6/12/78	Revised 6th and 7th line of Legend
DATE	REVISION
STATE OF HAWAII DEPARTMENT OF TRANSPORTATION HIGHWAYS DIVISION	
KEEHI INTERCHANGE ELECTRICAL PLAN - PART I	
INTERSTATE ROUTE H-1 PROJECT NO. I-HI-1(130):17	
SCALE: NONE	DATE: AUG. 16, 1976
SHEET No. E1 OF E12 SHEETS

8/3/77	RELOCATED COLUMN MOUNTED LUMINAIRE FOR AT GRADE ROADWAY FROM RAMP II TO RAMP I
DATE	REVISION
STATE OF HAWAII DEPARTMENT OF TRANSPORTATION HIGHWAYS DIVISION	
KEEHI INTERCHANGE ELECTRICAL PLAN - PART II STAGE II CONSTRUCTION	
INTERSTATE ROUTE H-1 PROJECT NO. I-HI-1 (130):17	
SCALE: N.T.S.	DATE: AUG. 16, 1976
SHEET NO. 52 OF 52 SHEETS

8/3/77	RELOCATED UNDERGROUND RACEWAY AND RUN-UP AT COLUMN FROM RAMP II TO RAMP I
DATE	REVISION
STATE OF HAWAII DEPARTMENT OF TRANSPORTATION HIGHWAYS DIVISION	
KEEHI INTERCHANGE ELECTRICAL PLAN - PART III STAGE II CONSTRUCTION	
INTERSTATE ROUTE H-1 PROJECT NO. I-HI-1(130):17	
SCALE: 1" = 50'	DATE: AUG. 16, 1976
SHEET No. E3 OF 12 SHEETS

DETAIL 4/EG
ARRANGEMENT OF EQUIPT
AT LUMINAIRE #4

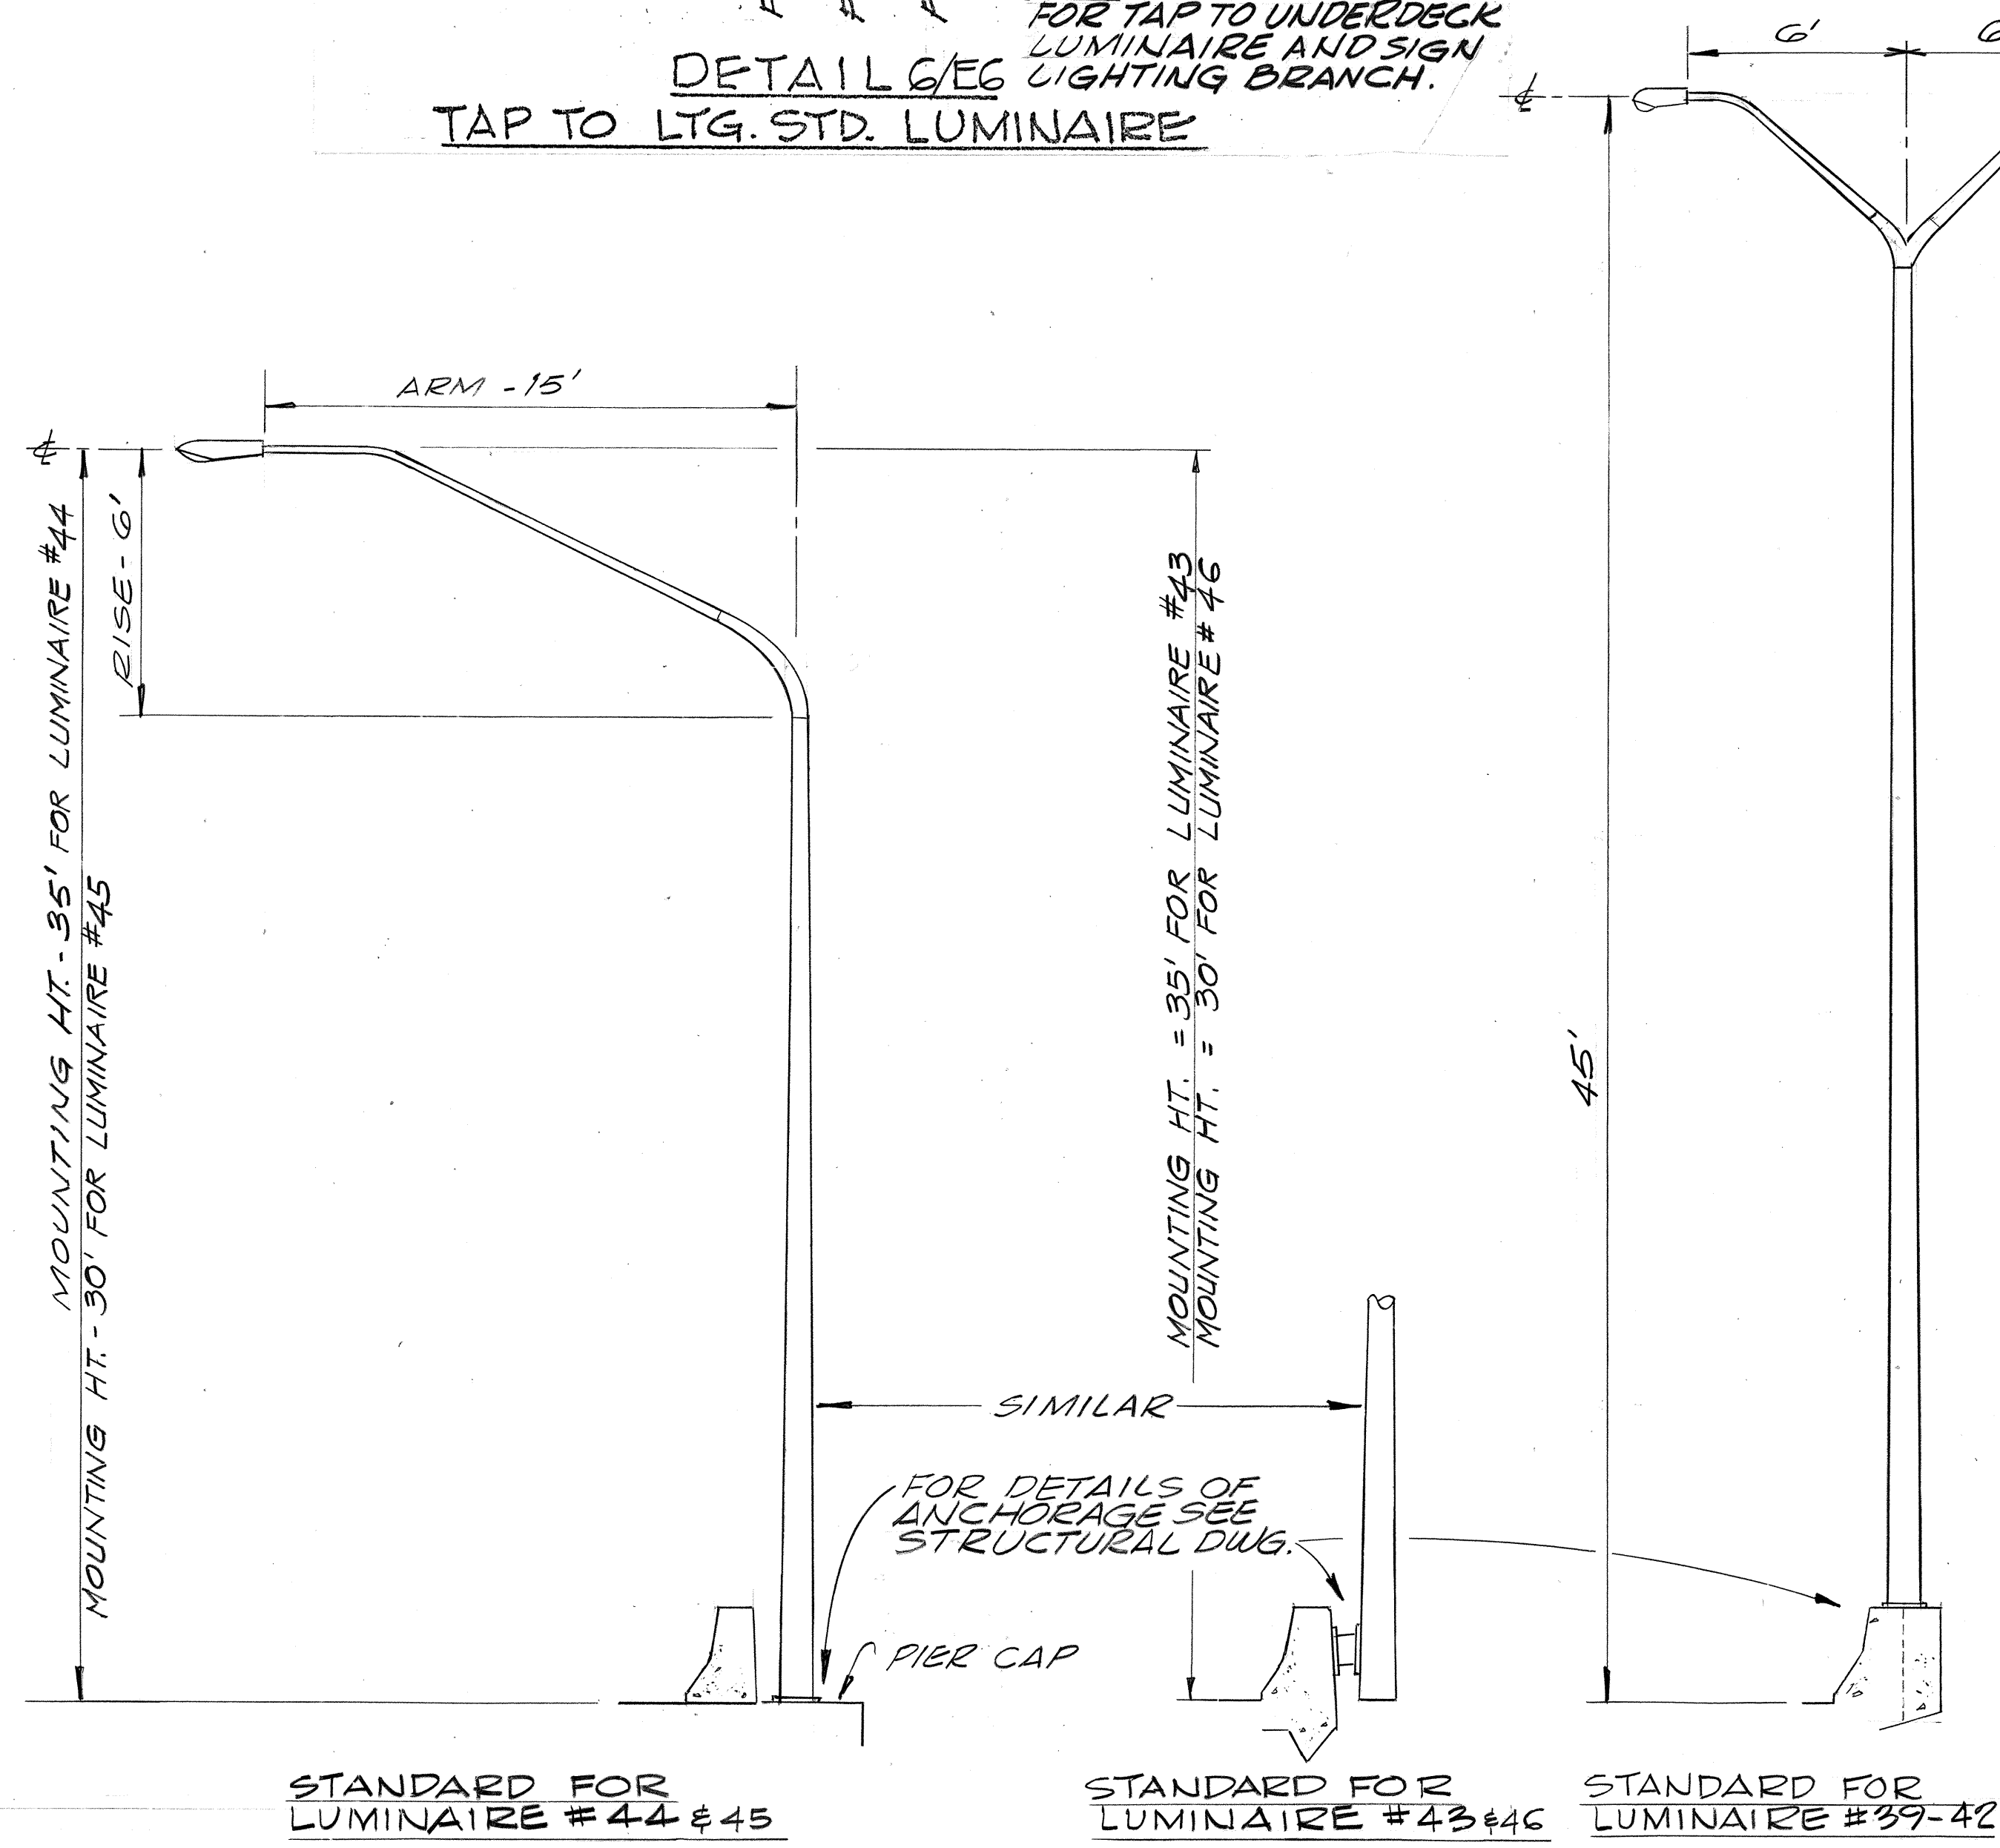
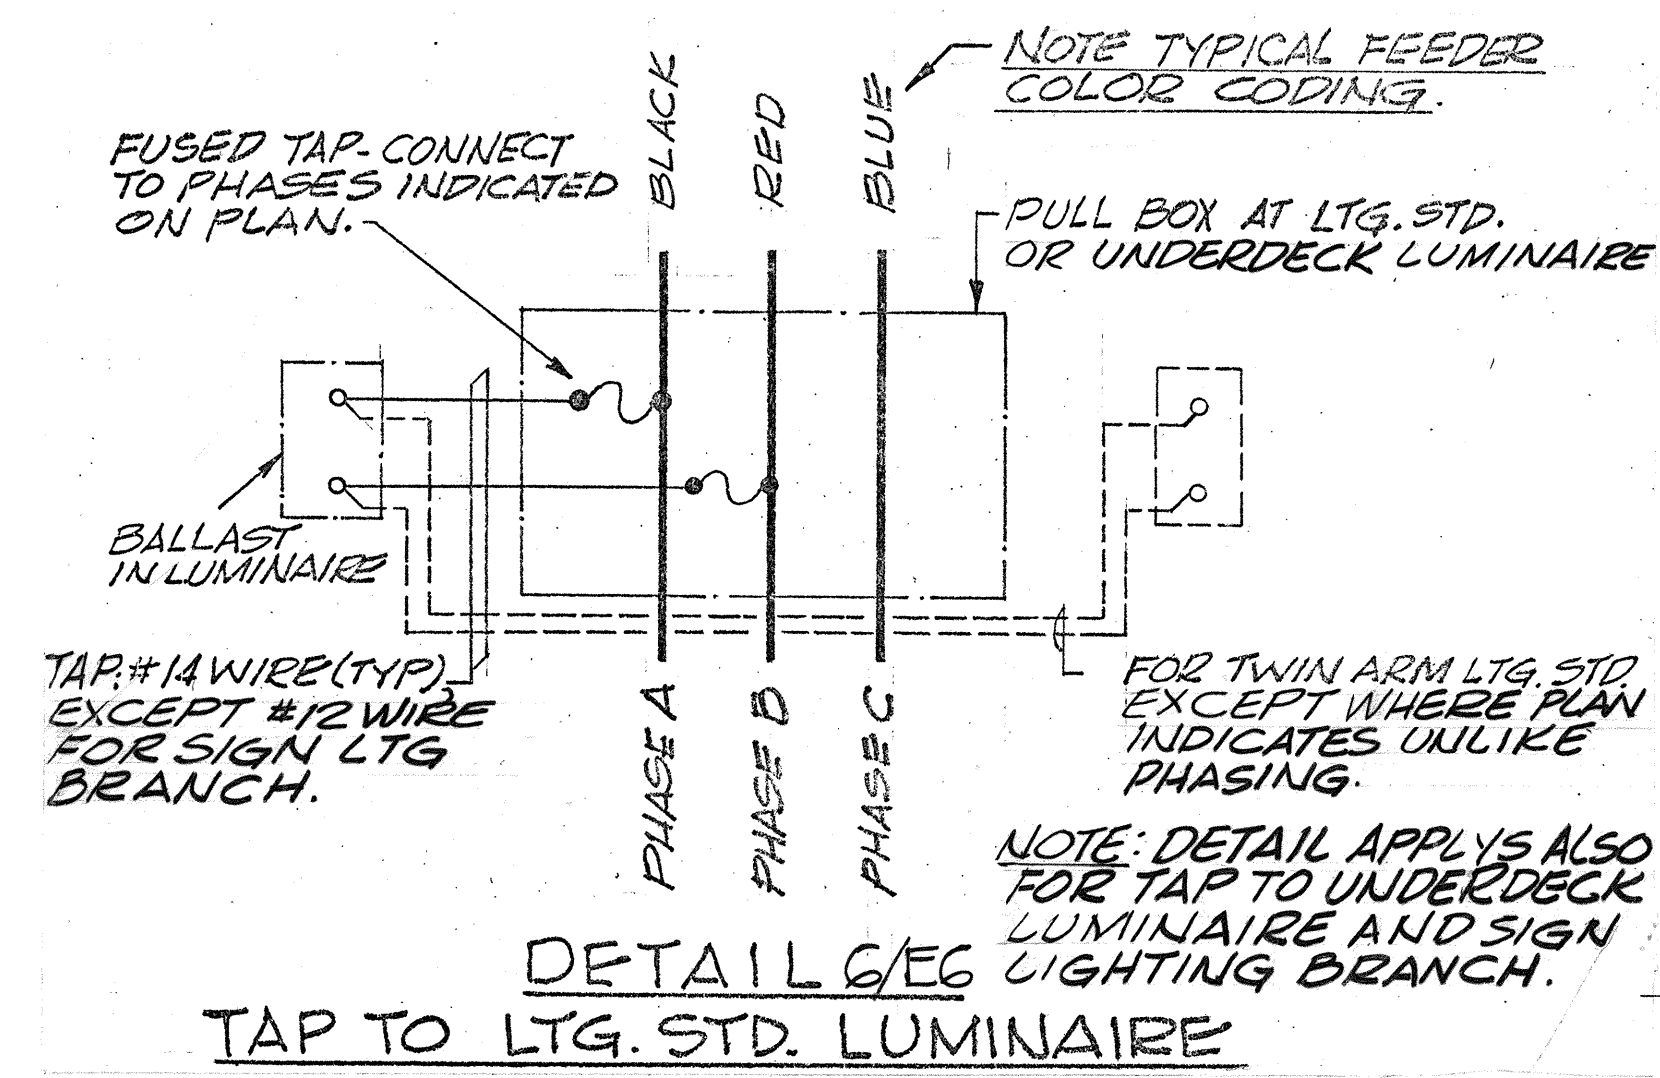
8/3/77	REVISED DETAIL 2/EG, FEEDER DIAGRAM, BY RELOCATING COLUMN MOUNTED LUMINAIRES FROM RAMP II TO RAMP I
DATE	REVISION
STATE OF HAWAII DEPARTMENT OF TRANSPORTATION HIGHWAYS DIVISION	
KEEHI INTERCHANGE ELECTRICAL PLAN - PART VI	
INTERSTATE ROUTE H-1 PROJECT NO. I-HI-1 (130):17	
SCALE: NONE	DATE: AUG. 16, 1976
SHEET NO. EG OF E/2 SHEETS

Change Order #22

DETAIL 1/E10
SIGNAL AND LIGHTING PLAN
INTERSECTION NO. 2 - 1A.
SEE NOTE 1/E10.

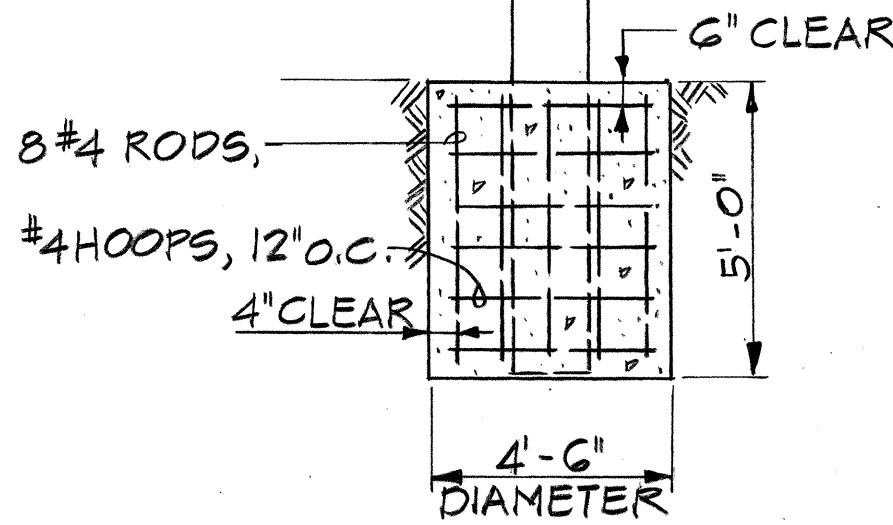
Three 6'x6' loop
detectors at
Baseline Detour #1
Sta. 18+05. Connect
to traffic signal
interconnect system
at existing light pole
on Nimitz Hwy. outbound
C.O. #9

Actual Location -
C.O. No. 2

3/12/77 REVISED DETAIL 1/E10
TO REFLECT USE OF
EXISTING POLES B4Q

10/20/76 REVISED DETAIL 1/E 10,
REVISED NOTE 4 AND
ADDED NOTE 10

DETAIL 1/E11
 SIGNAL AND LIGHTING PLAN
 INTERSECTION NO 2-1B
 SEE NOTE 1/E11.

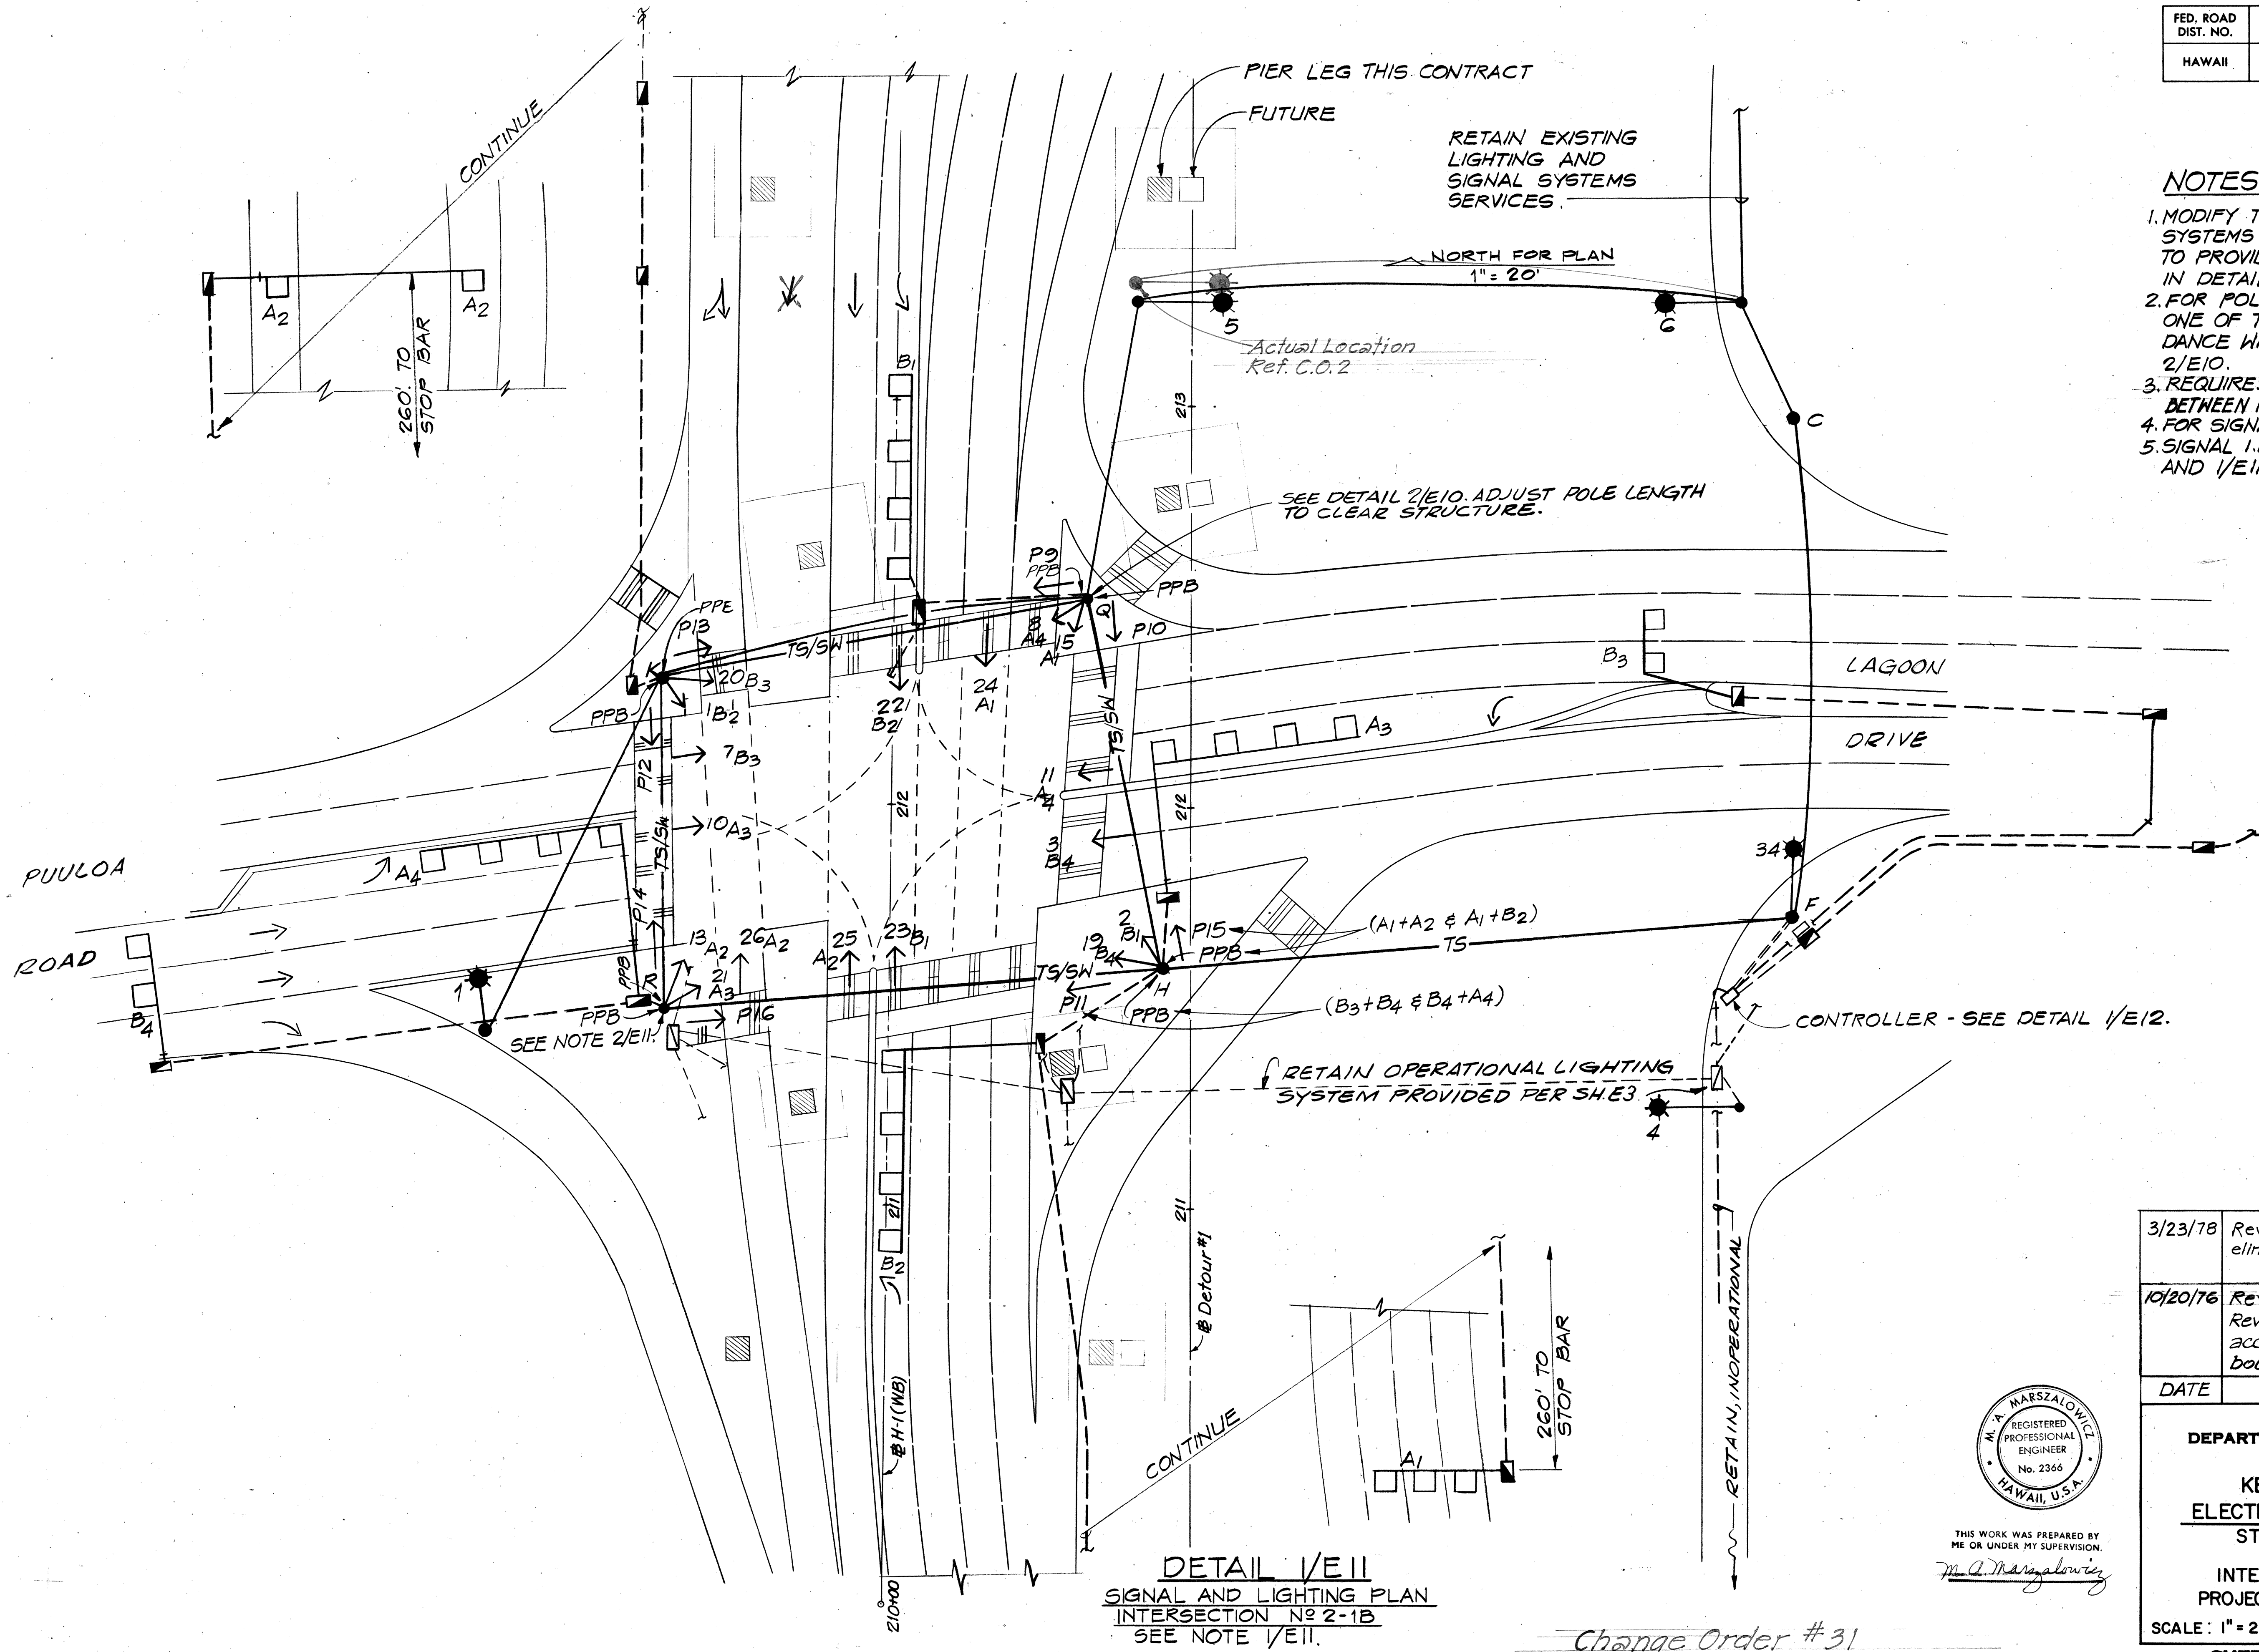
3/23/78	Revised traffic channelization to eliminate one westbound lane.
10/20/76	Revised Note 3 Revised traffic channelization to accommodate additional westbound lane.
DATE	REVISION
STATE OF HAWAII DEPARTMENT OF TRANSPORTATION HIGHWAYS DIVISION KEEHI INTERCHANGE ELECTRICAL PLAN - PART XI STAGE II CONSTRUCTION INTERSTATE ROUTE H-1 PROJECT NO. I-HI-1 (130):17 SCALE: 1" = 20' DATE: AUG. 16, 1976 SHEET No. E11 OF E12 SHEETS
